**Addendum No. 1  
September 27, 2021**

Project: **Harrisburg Middle School No. 3**  
Harrisburg, South Dakota  
Architecture Incorporated Project #2903

Architect: Architecture Incorporated

**SD6**

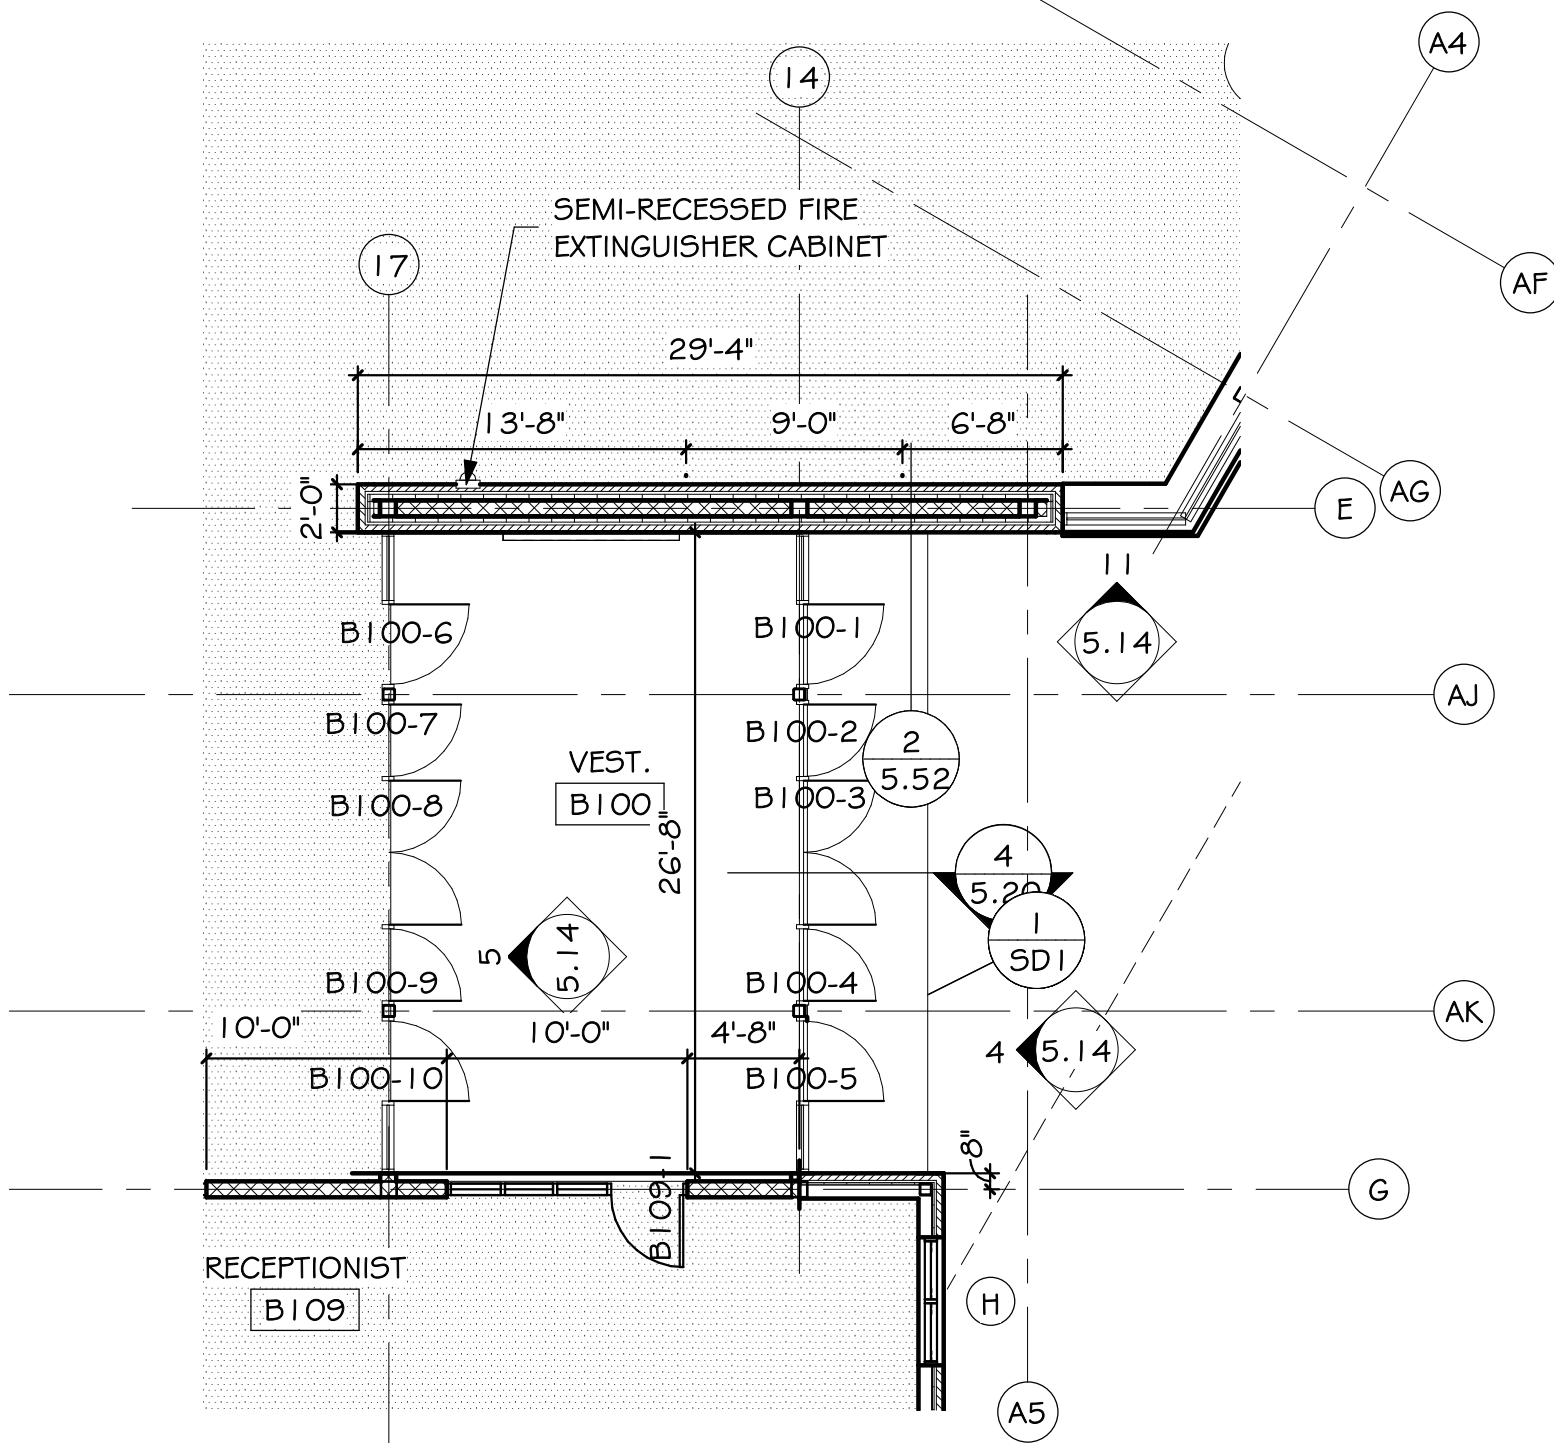
- i) Reference Section 126600 “*Telescoping Stands*” for additional information.
- c) Omit the sink in Office A130.
- d) Reference attached supplemental drawing SD6 dated September 27, 2021 for Semi-Recessed Fire Extinguisher Cabinet in Hall A134.

SD7

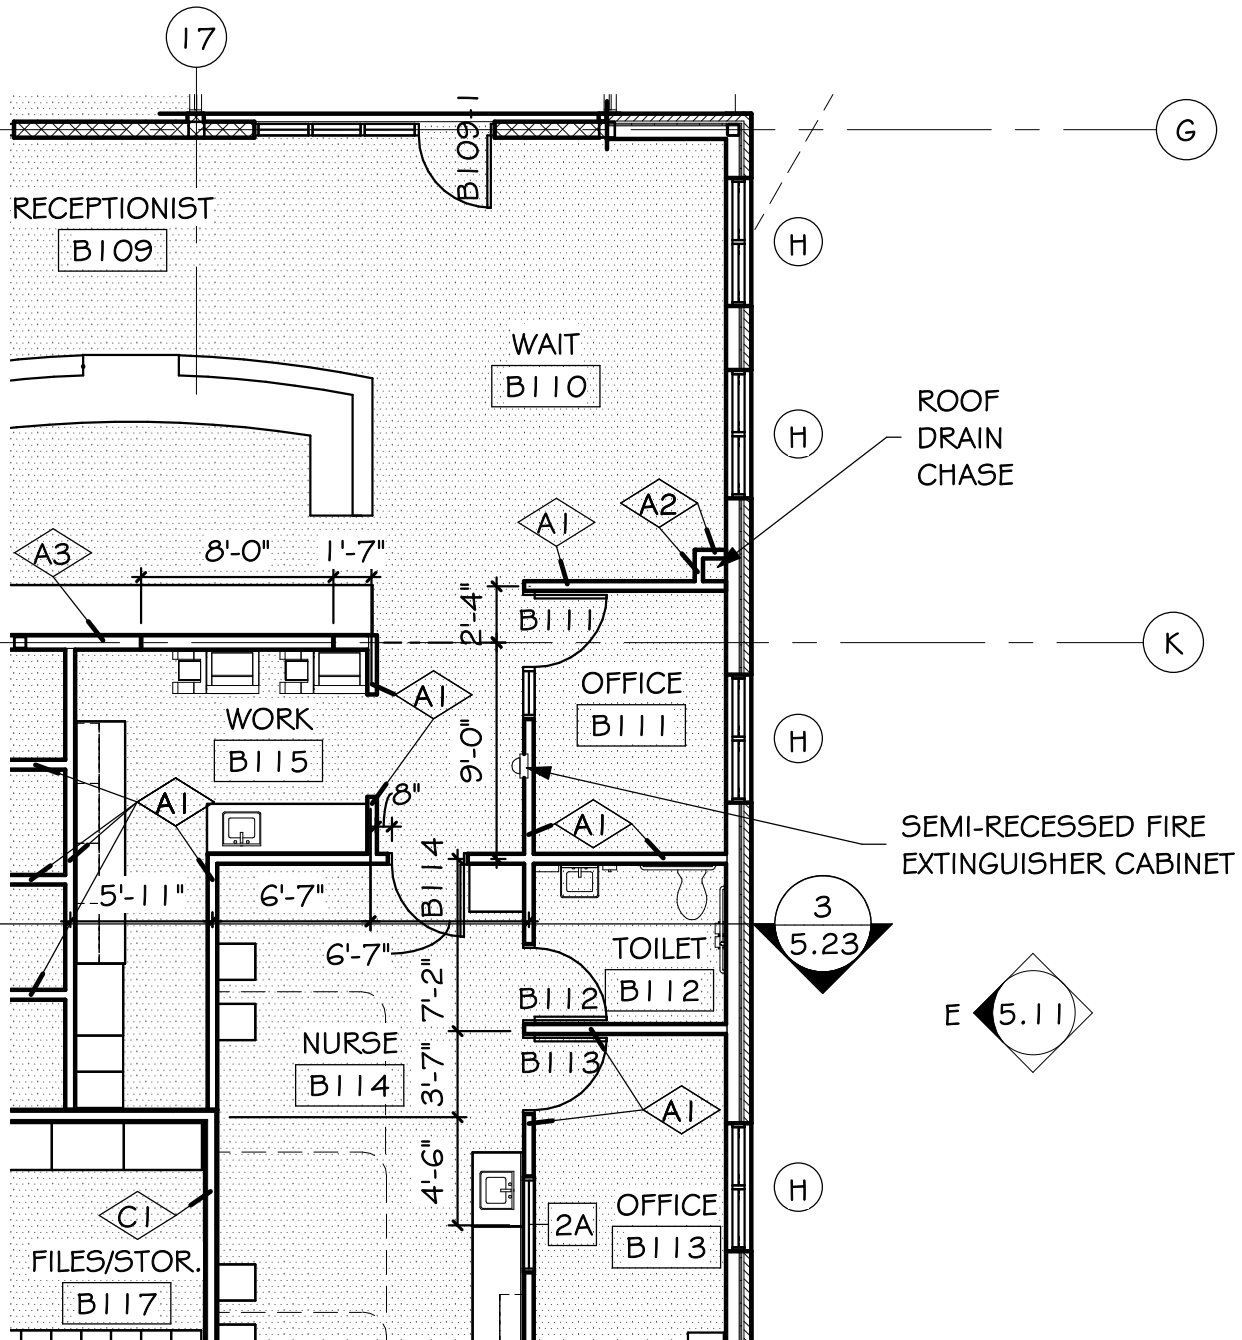
- a) Reference attached supplemental drawing SD7 dated September 27, 2021 for Semi-Recessed Fire Extinguisher Cabinet in Commons B157.
- b) Reference attached supplemental drawing SD8 dated September 27, 2021 for Semi-Recessed Fire Extinguisher Cabinet in B110 Wait.
- c) Reference attached supplemental drawing SD9 dated September 27, 2021 for Semi-Recessed Fire Extinguisher Cabinet with class K wet chemical fire extinguisher in Kitchen B154.
- d) Reference attached supplemental drawing SD10 dated September 27, 2021 for Wall-Mounted Fire Extinguisher Cabinet in Receiving B147.
- e) Provide a semi-recessed fire extinguisher cabinet in Hall B154A adjacent to borrowed lite Type 3.

Sheet Contents  
**FOOTING & FOUNDATION PLAN- AREA B- PLMB & HTG**

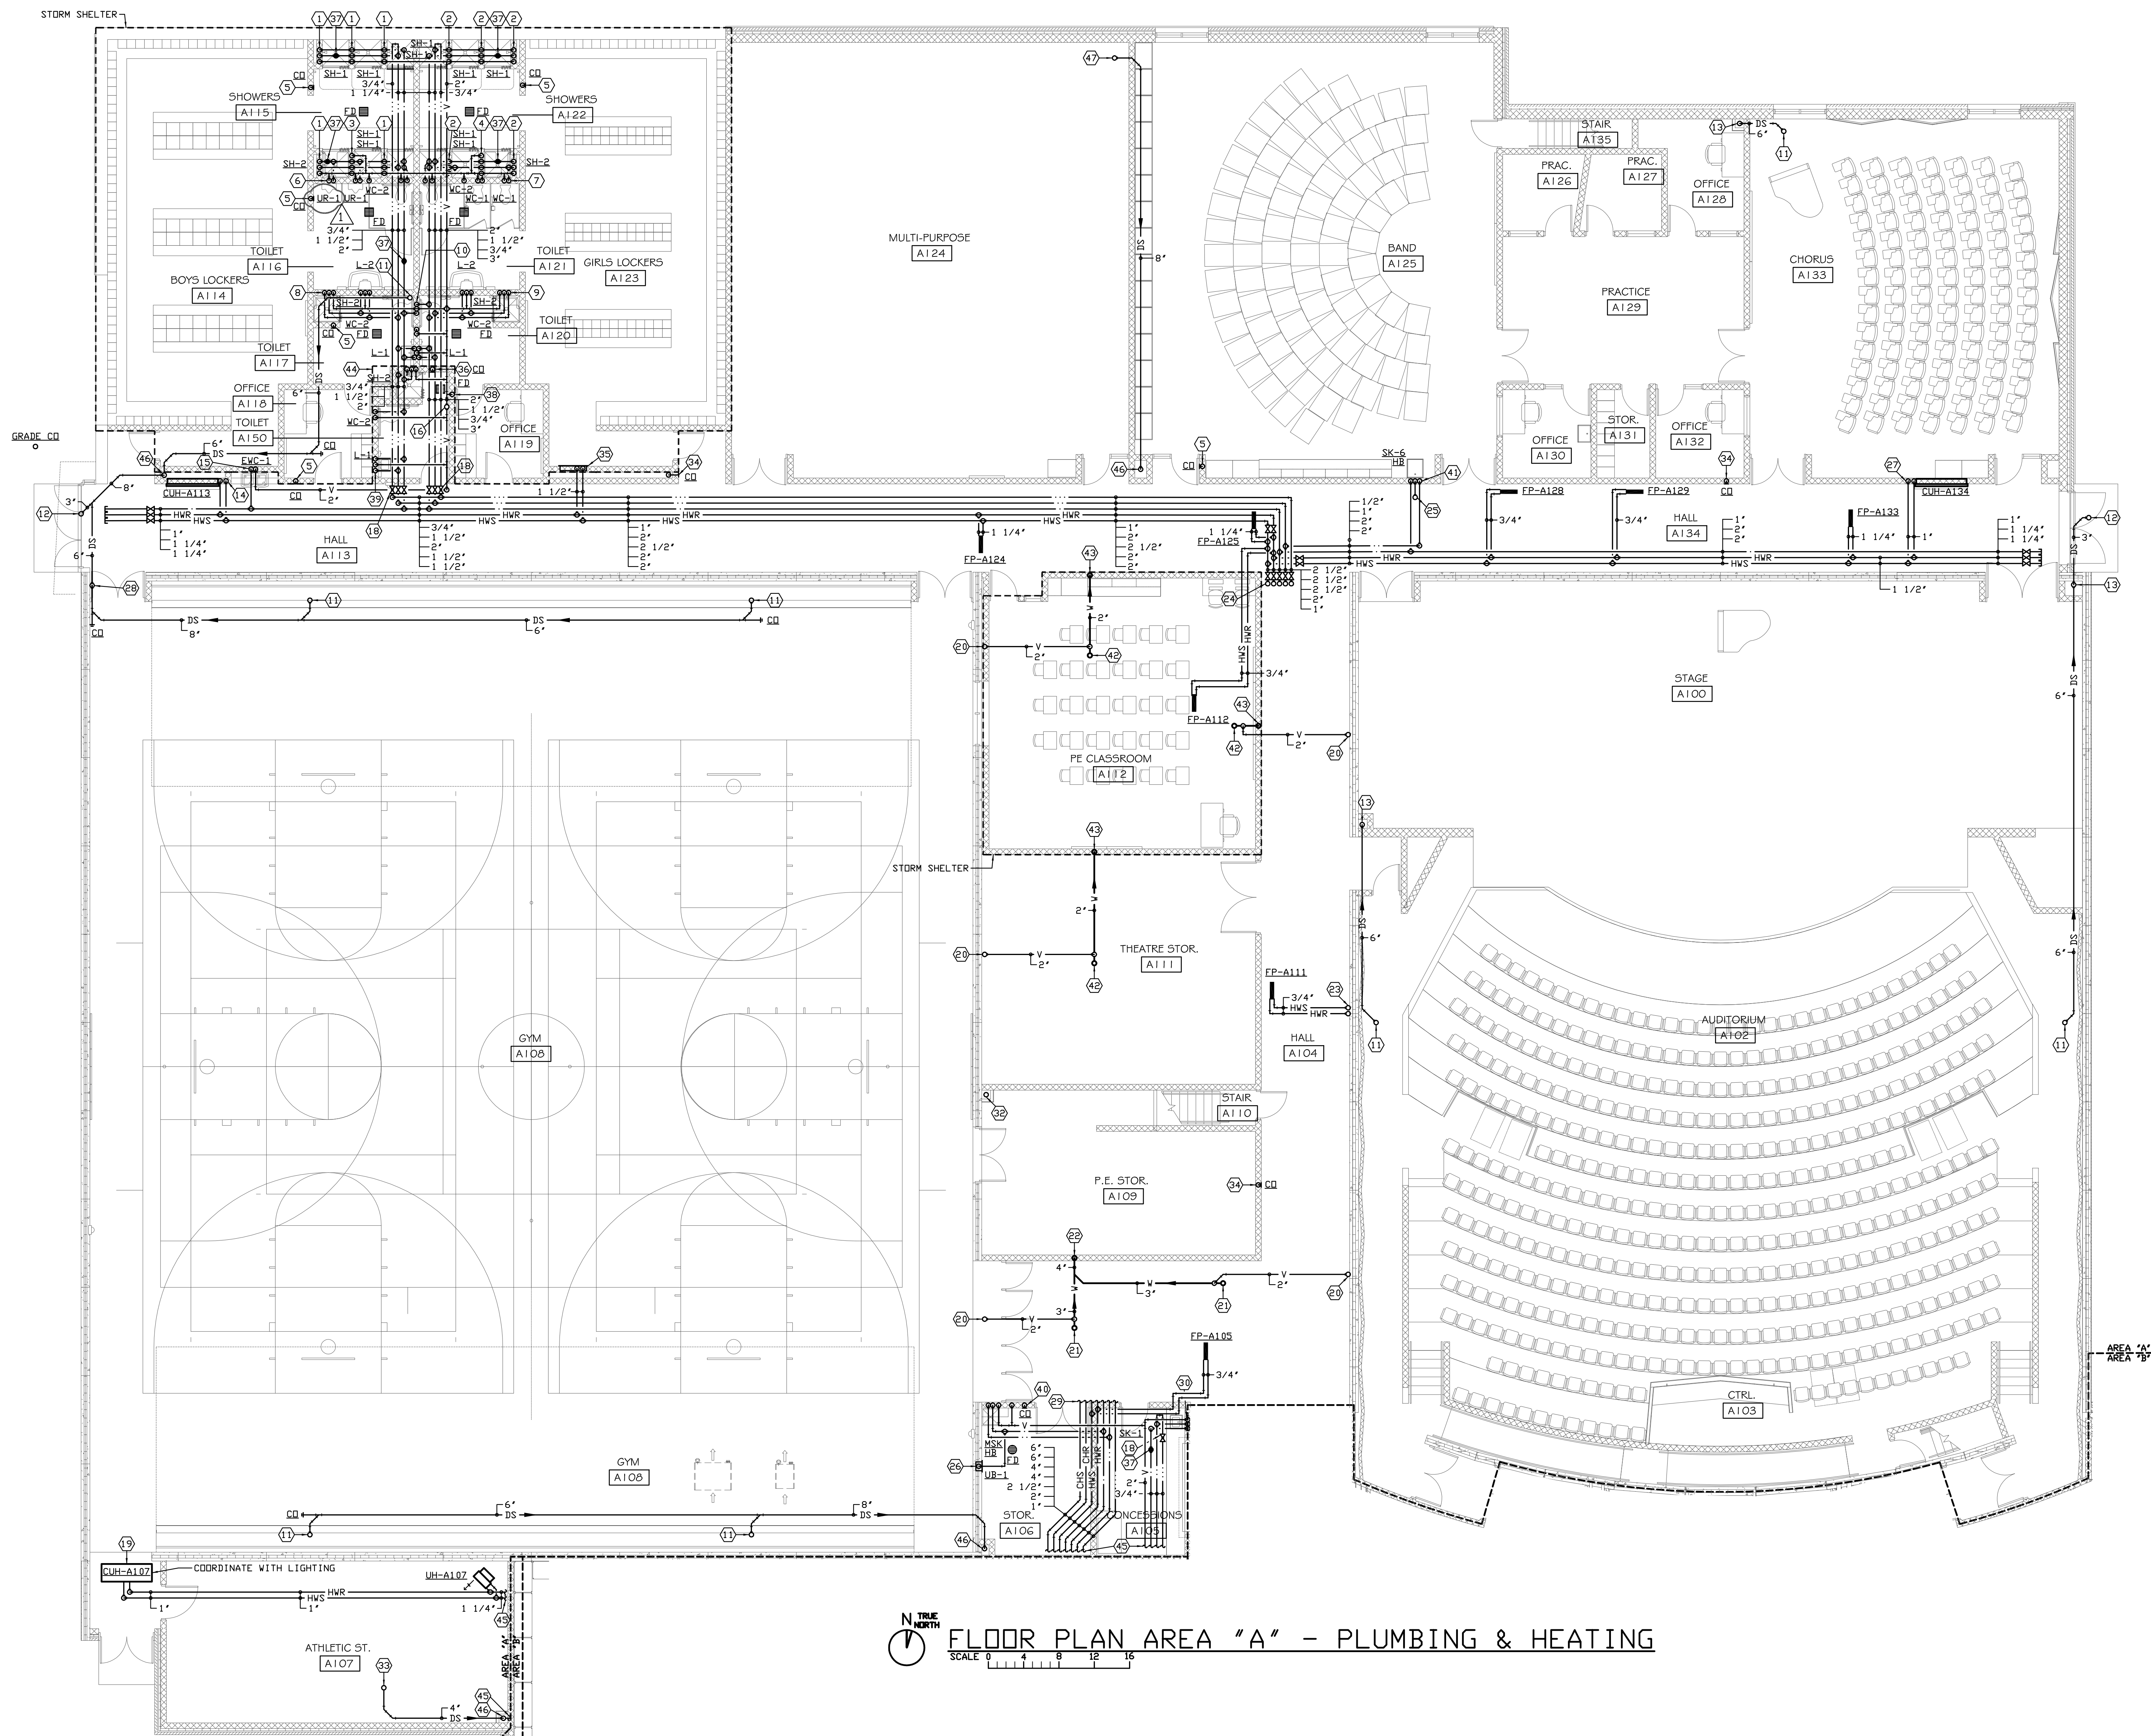
- a) Refer to revised mechanical drawing Sheet 8.21, revision dated 9-27-21, attached to the end of Addendum #1 for the following:
    - i) Add “GREASE TRAP DETAIL”.

- ii) Add grade CO to match “GREASE TRAP DETAIL” on floor plan.
    - iii) Revise routing for waste for FSK under hood in kitchen to go to the grease trap.

- iv) Add sand-oil interceptor in lieu of floor drain with sediment bucket, including corresponding vent piping, cleanouts, and pipe routing.
    - v) Revise FSK & FD routing to new sand-oil interceptor, including removal of venting and inclusion of note describing the drains being untrapped and unvented.
